RE: Completeness Review for Class 3 Site Plan Review for Property Located at 4555 Liberty Road S

SUBWAY
SUNNYSLOPE CENTER
4555 LIBERTY RD. SOUTH
SALEM OREGON

**FULL
SITE PLAN**

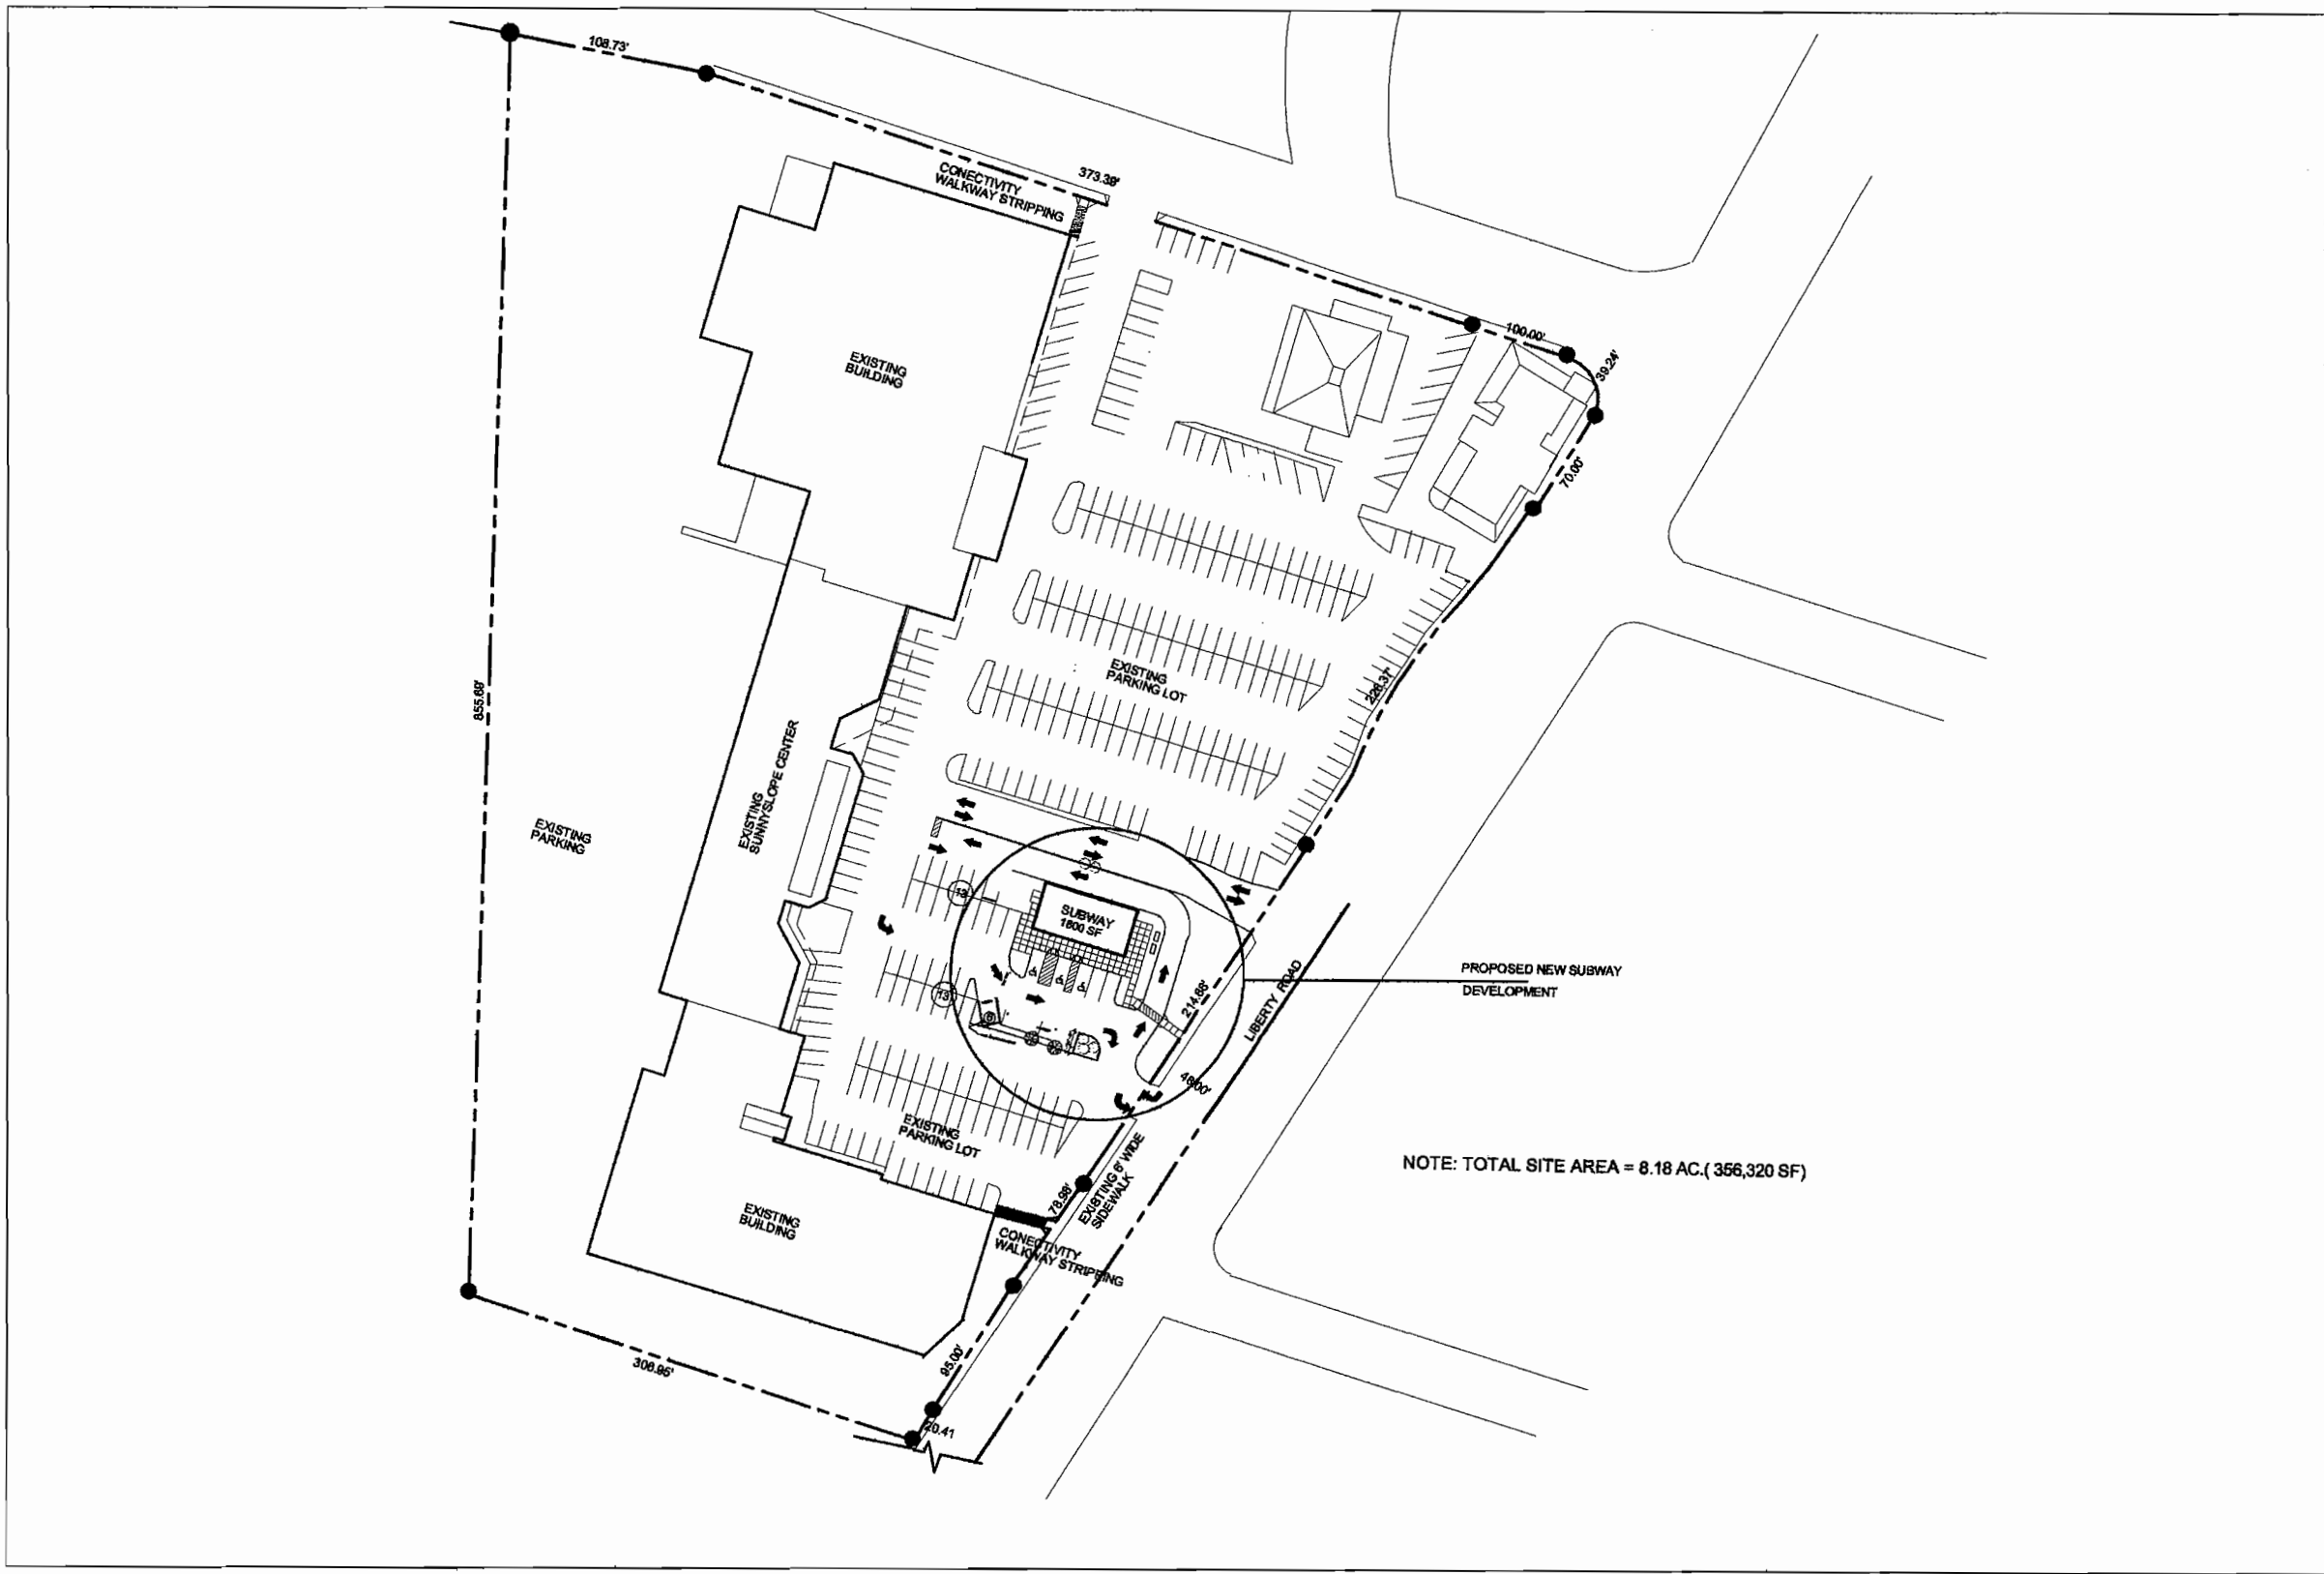
- **Existing Conditions:** The proposed site plan and existing conditions plan do not match the approved site plans the City has on file in the following way(s):

- *Off-street parking area, trash enclosure, bicycle rack, and landscaping to the south and west of the Subway building.* Based on permit history and aerial imagery, it appears a trash enclosure, bicycle rack, and some landscaped areas were removed, and the off-street parking area was reconfigured, sometime around 2011-2012. The proposal will need to include returning this area to the approved layout (see **Attachment A**), or this portion of the development site will need to be reviewed under the current standards of the SRC along with the area containing the proposed Sherwin Williams building. The applicant can also submit evidence this work was done with the necessary approval from the City, though I was unable to locate anything in our system which would indicate this.
